ADDENDUM NO. 1
TO
PROCUREMENT AND CONTRACTING REQUIREMENTS
FOR
NineStar CR200 Sewer – Division I
FOR
NINESTAR CONNECT
Issue Date: October 25th, 2023

The following, as additions to and modifications in the Bidding Requirements and Contract Documents, will be included in, and become a part of the **NineStar CR200 Sewer – Division I**. This Addendum forms a part of the Contract Documents. Bidders are, therefore, instructed to take the following into account in rendering any Bid for this work. Acknowledge receipt of this Addendum in the space provided on the Bid Form.

E408

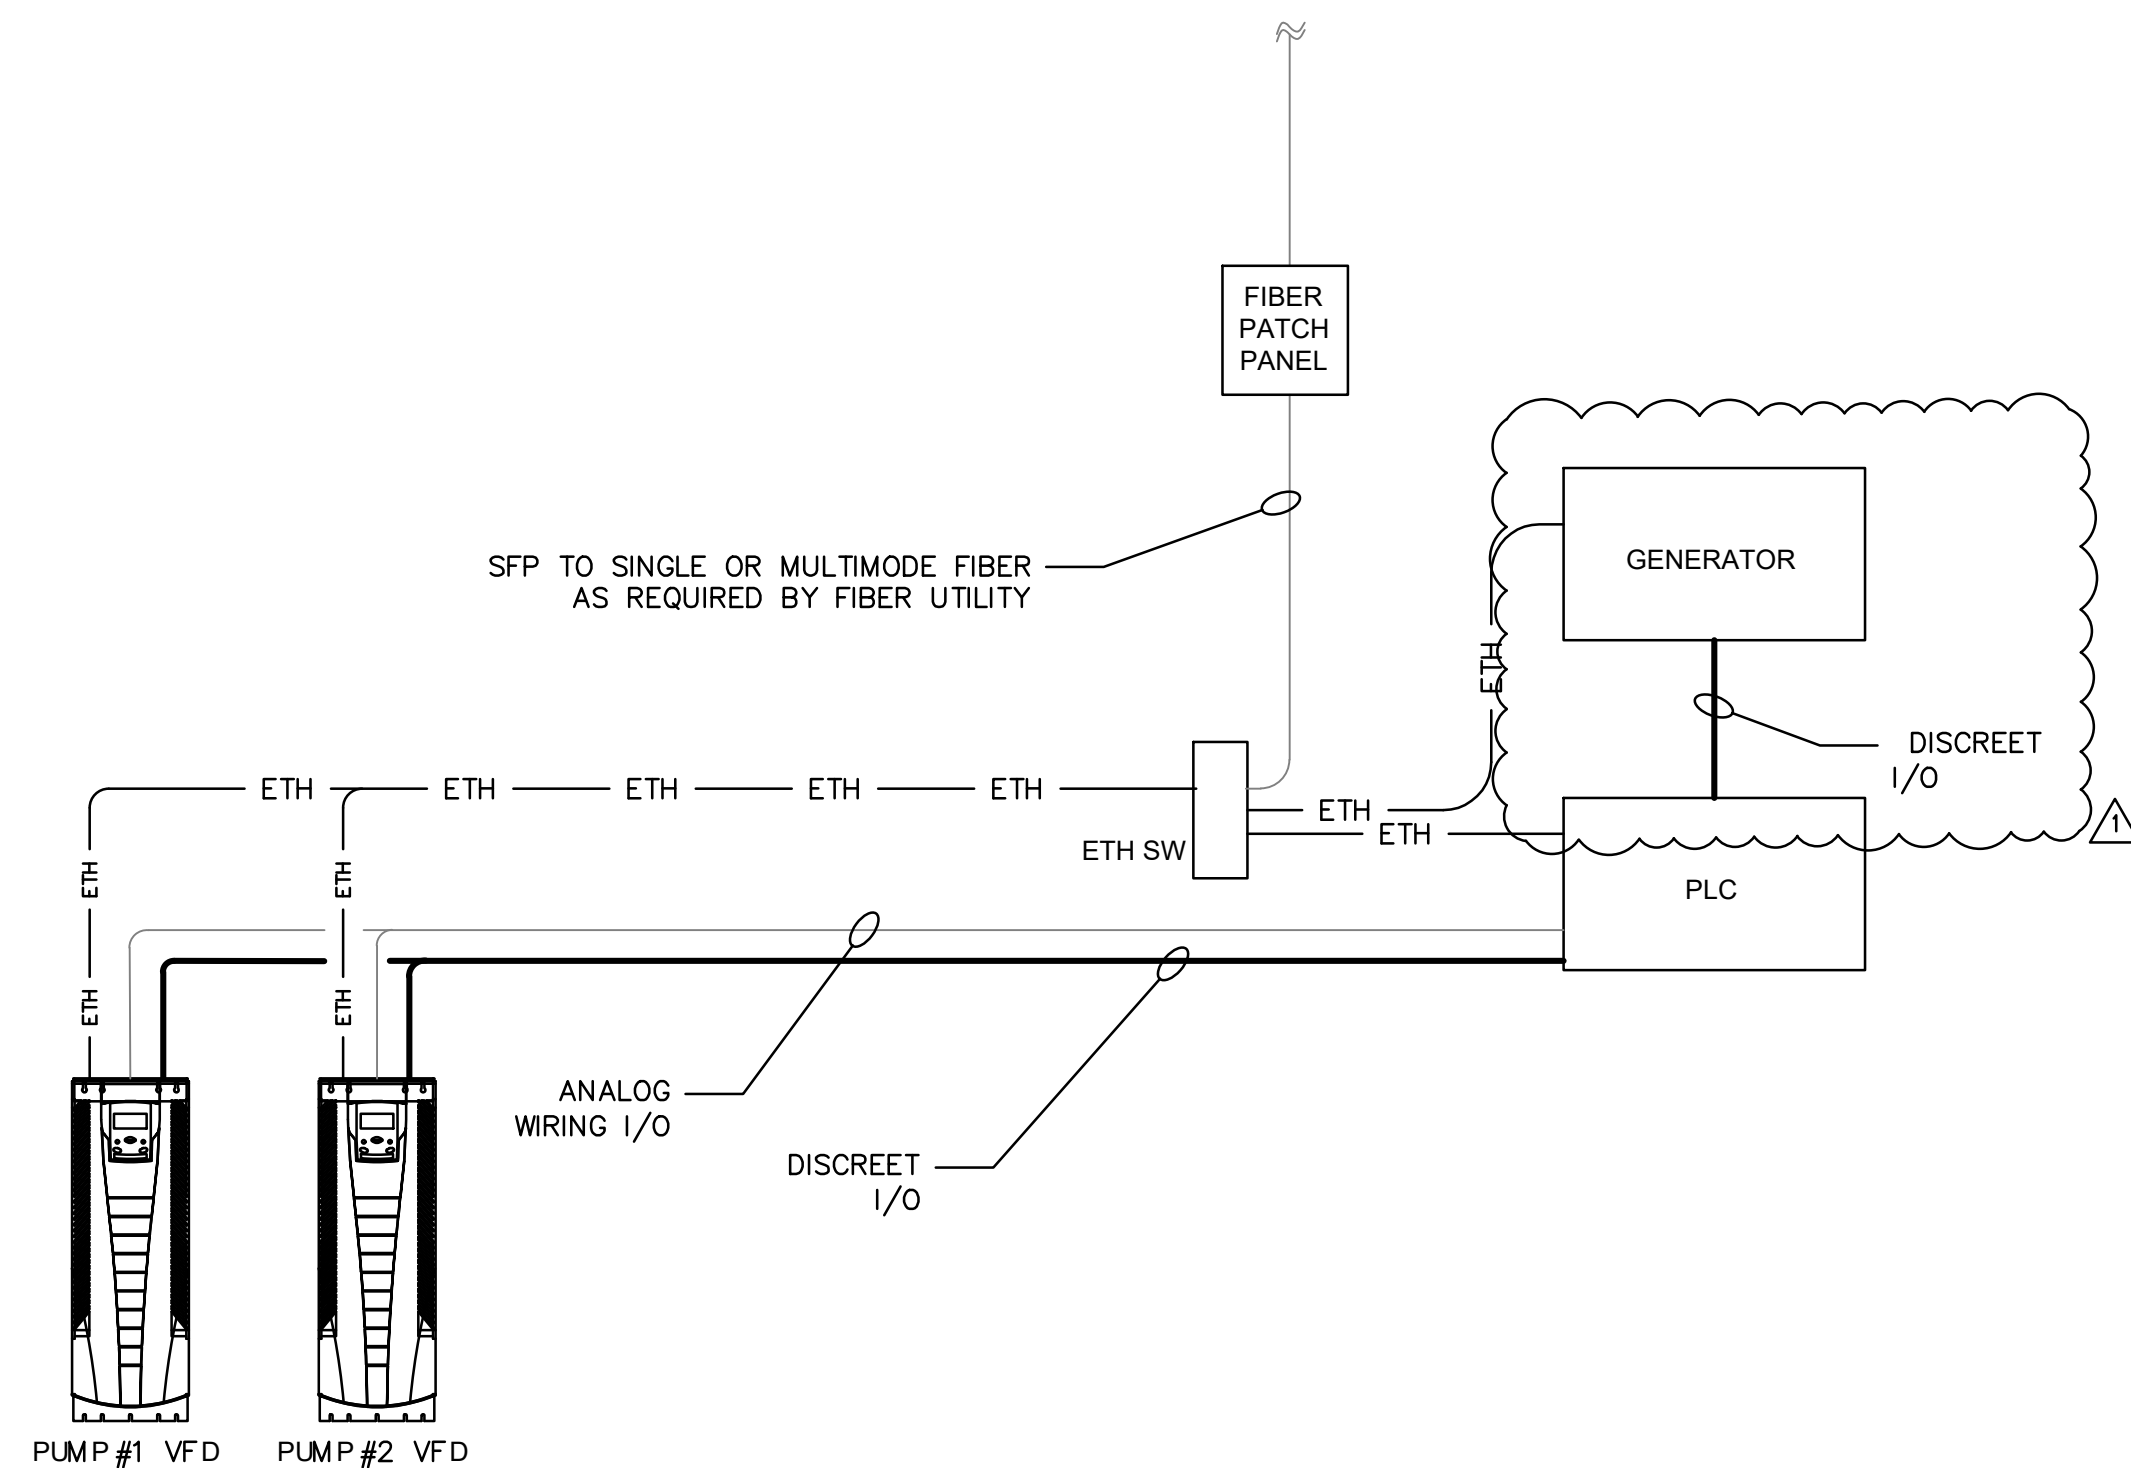
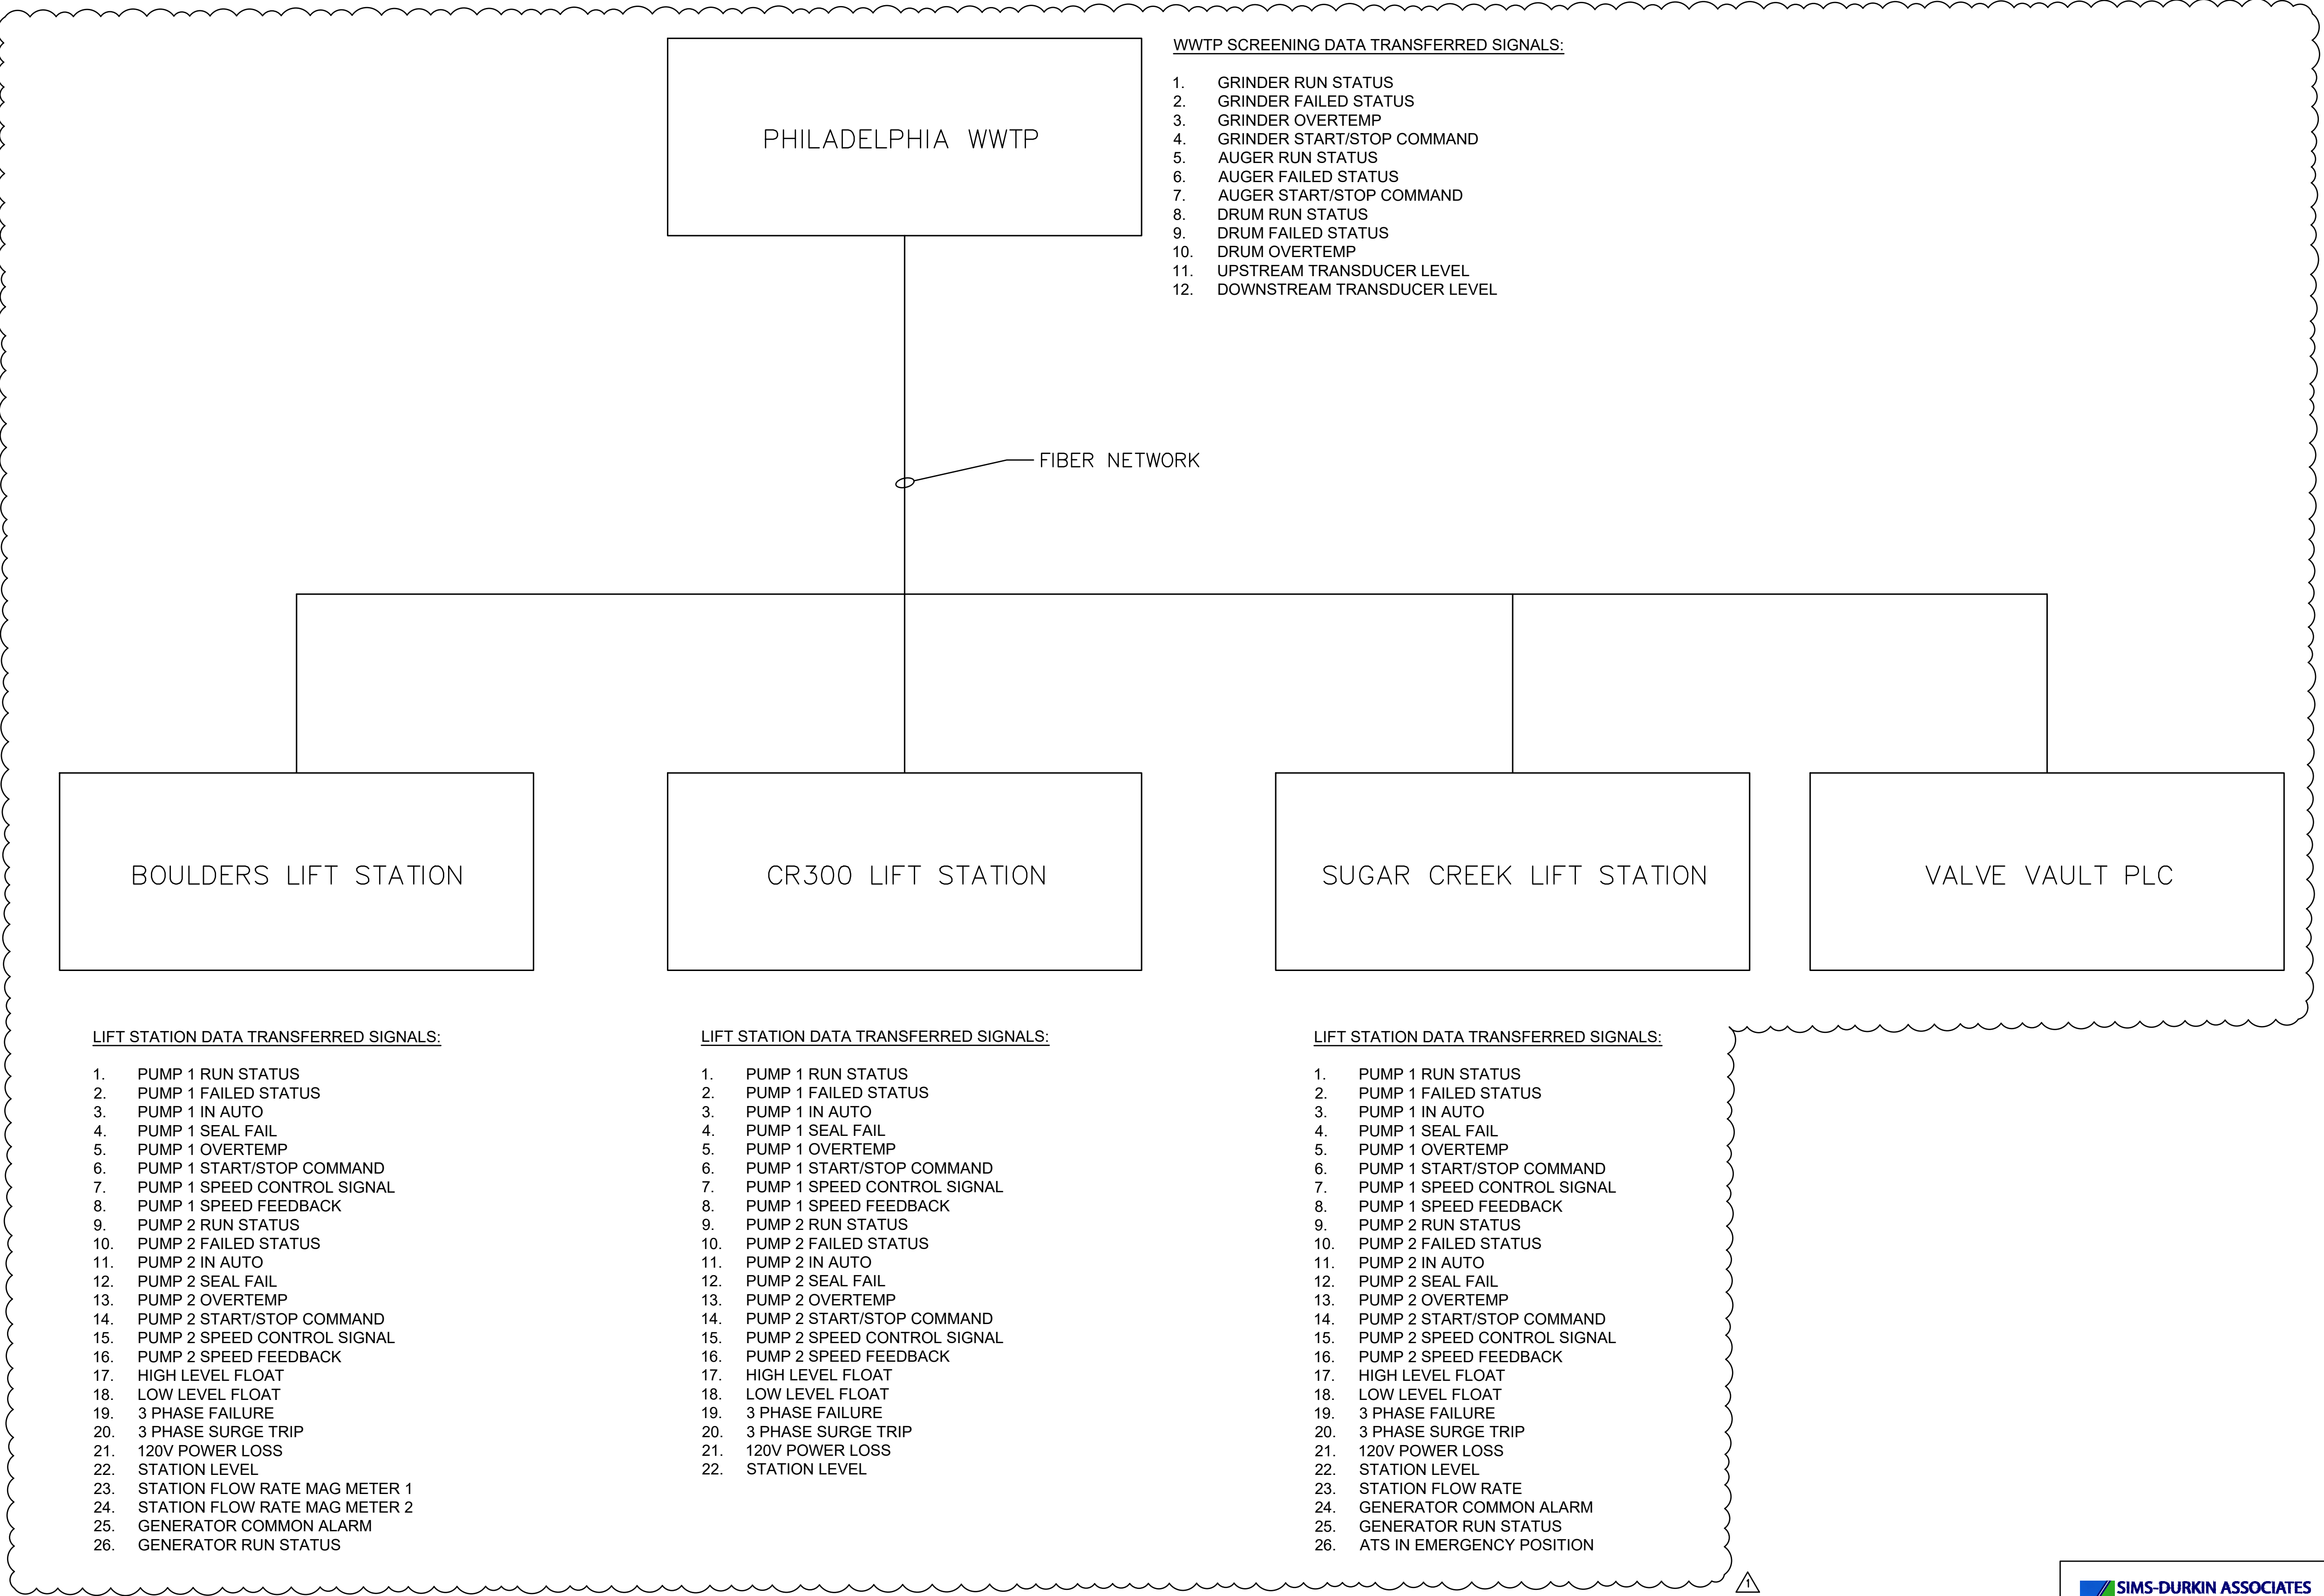
- w. Sheet E406 – Sugar Creek Pump Control Panel Wiring Details Cont (Added generator alarms and ATS for emergency power alarm)
- x. Sheet E408 – Sugar Creek Pump Control Panel Wiring Details Cont (Ensured generator in overview.)
